**CITY OF GRASS VALLEY
ENGINEERING DIVISION**

ADDENDUM NO. 1

**CDBG MEMORIAL PARK FACILITIES IMPROVEMENT
PROJECT, PROJECT NO. 20-05**

ADDENDUM NO. 1

CITY OF GRASS VALLEY ENGINEERING DIVISION
**CDBG MEMORIAL PARK FACILITIES
 IMPROVEMENT PROJECT**
 LAP POOL DETAILS AND SECTIONS

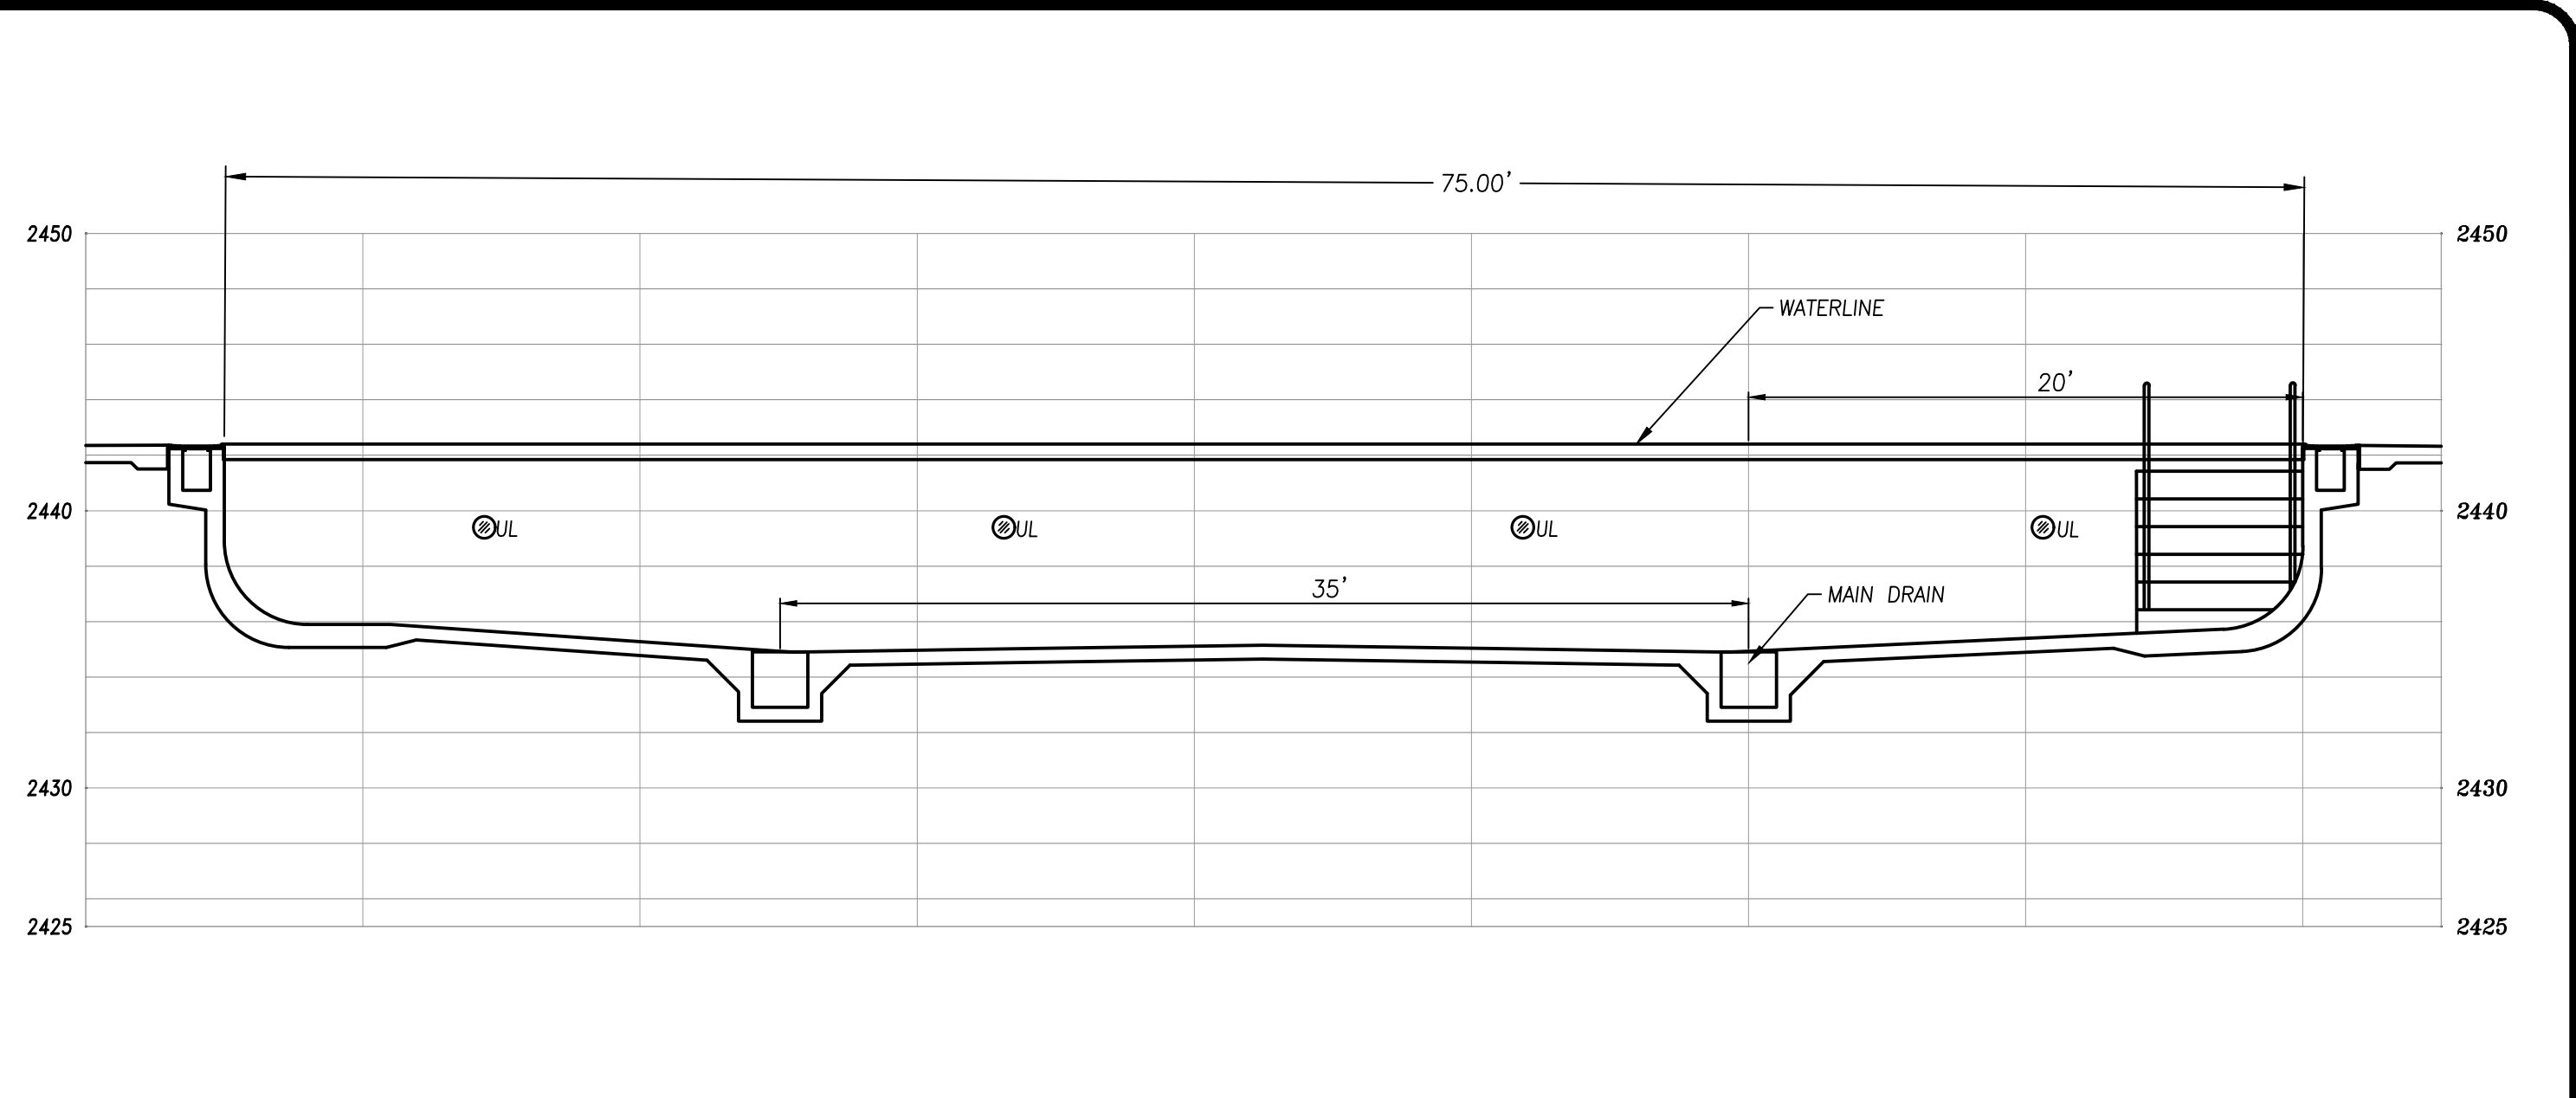
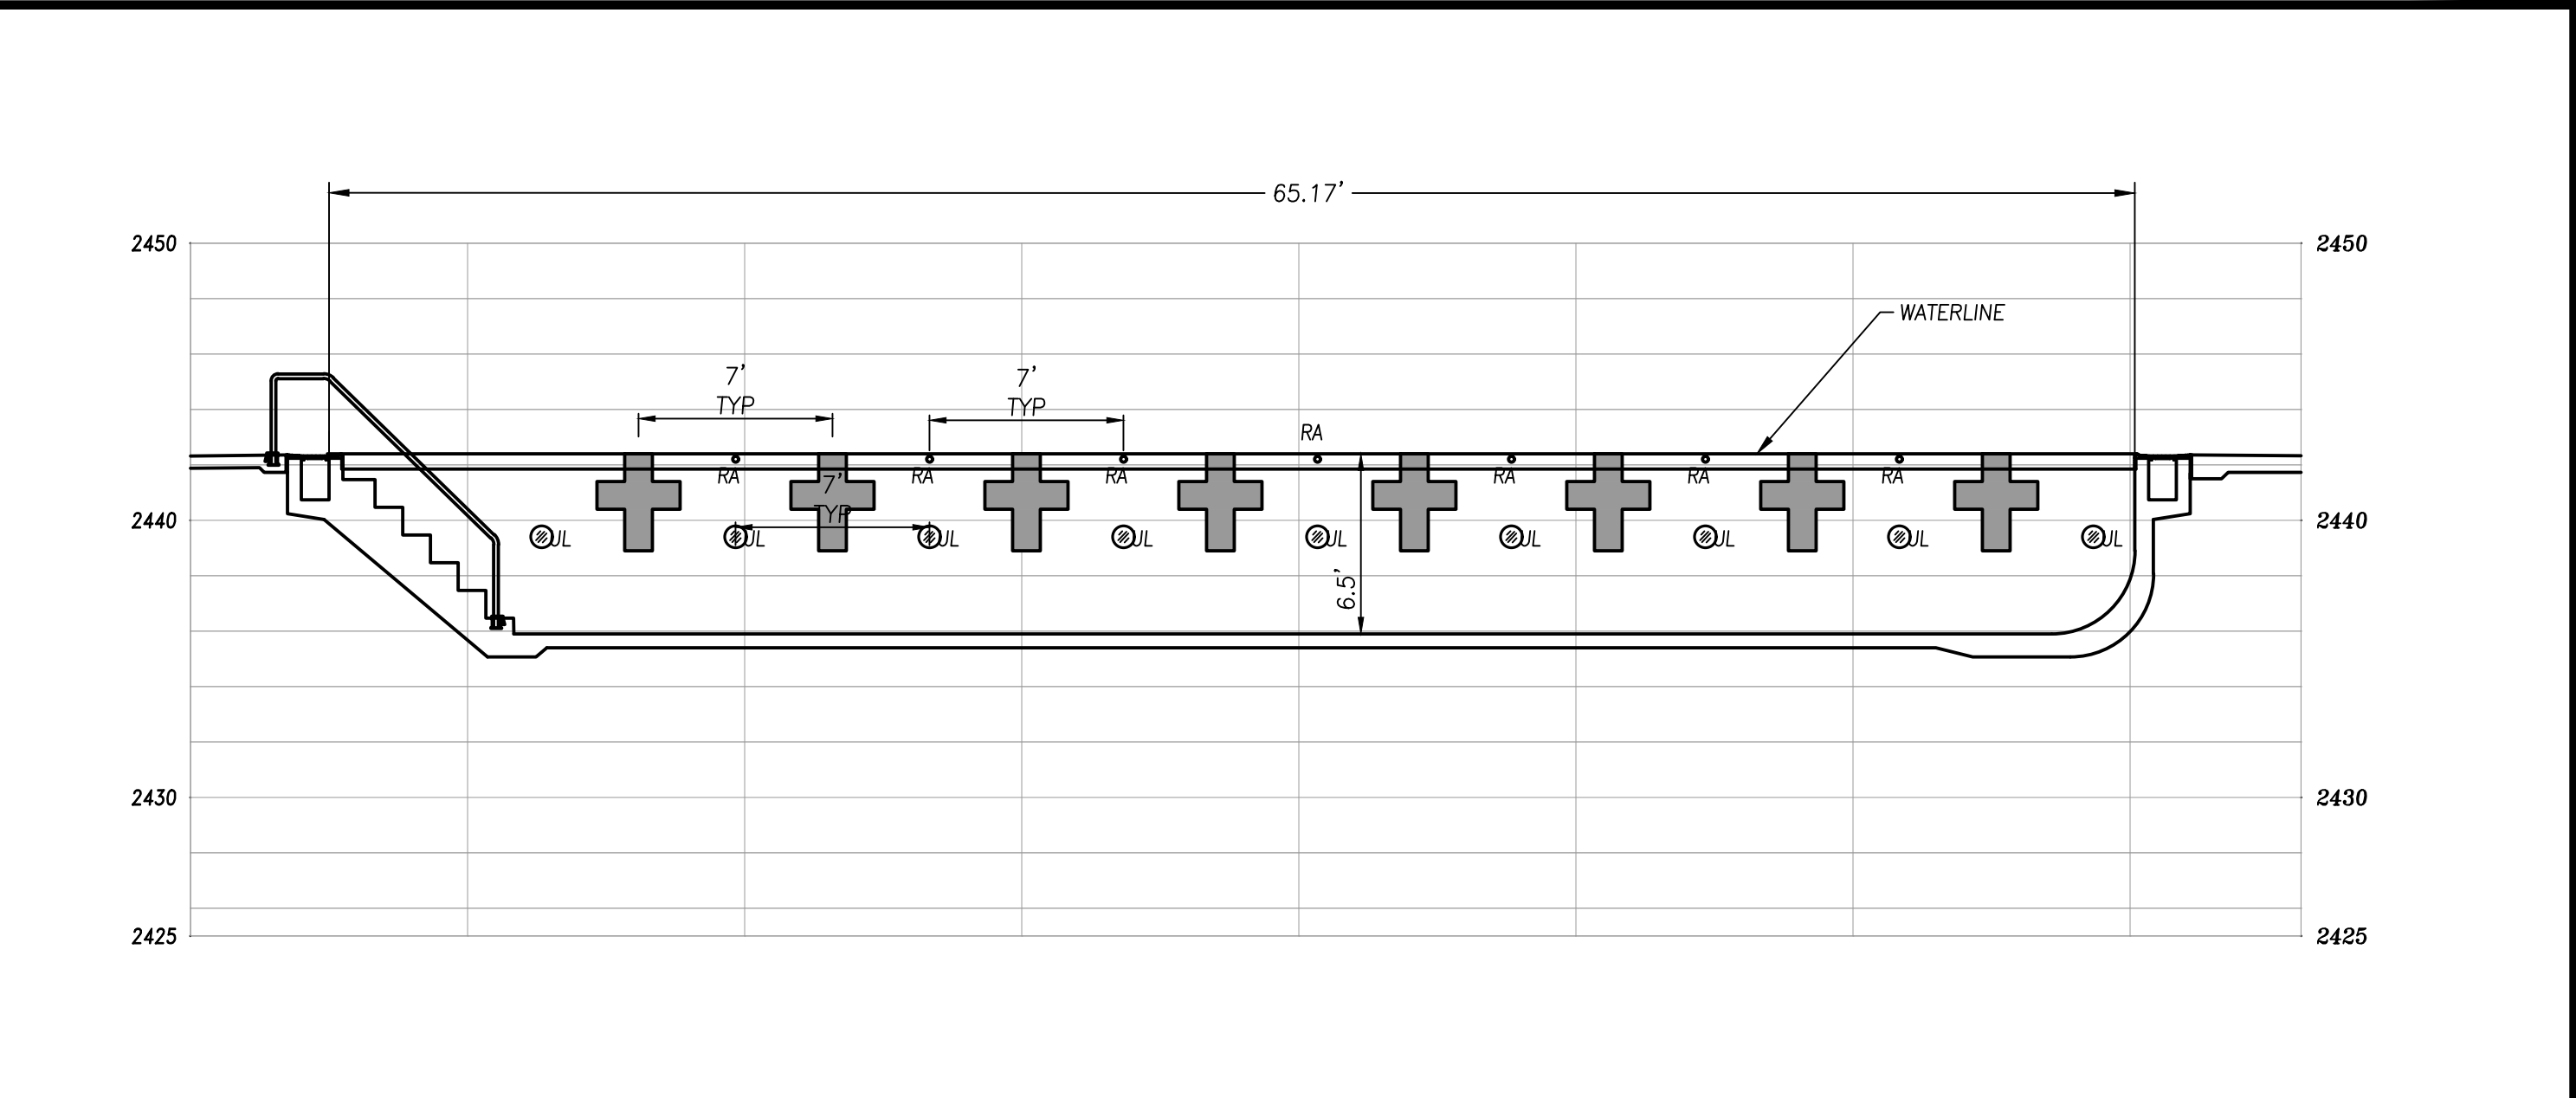
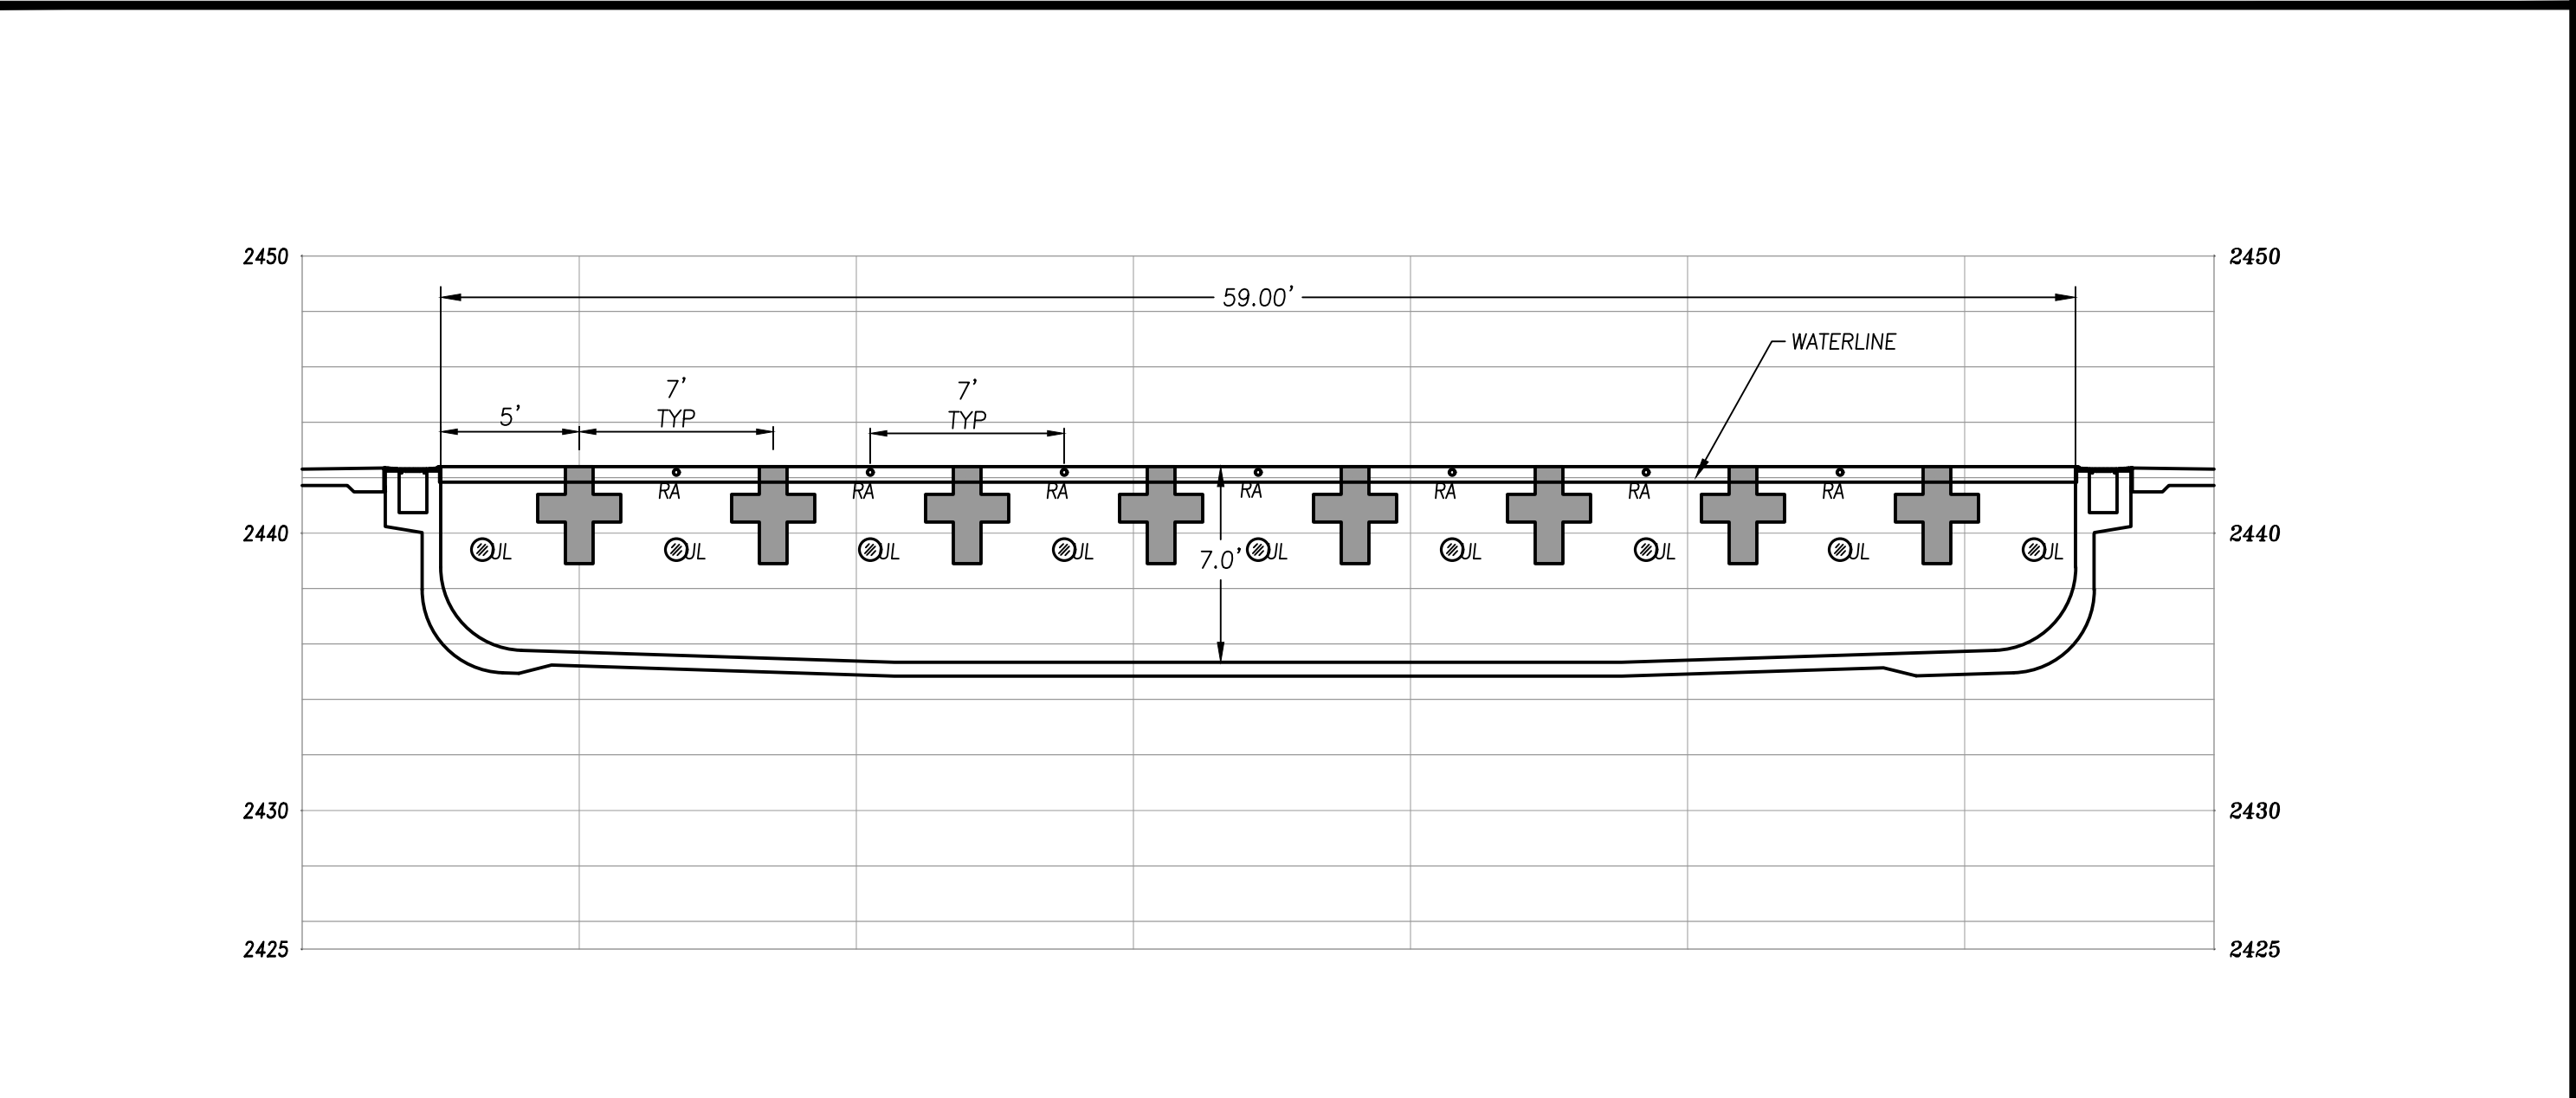
1. Sheet 1, Sheets 3 through Sheet 6, and Sheet 19. Replace the sheets in their entirety with the attached revised sheets. Remove reference to pool details. Modify the Activity Pool layout and cross sections. Move Seat Retaining Wall detail to sheet 19.
2. Sheets 7 through Sheet 9. Delete all pool details from the bid plan set.

REVISIONS		APPROVAL	Date
No.	Description	Engr Init	By
1	REV REF TO DETAILS	BPJ	3/29/21
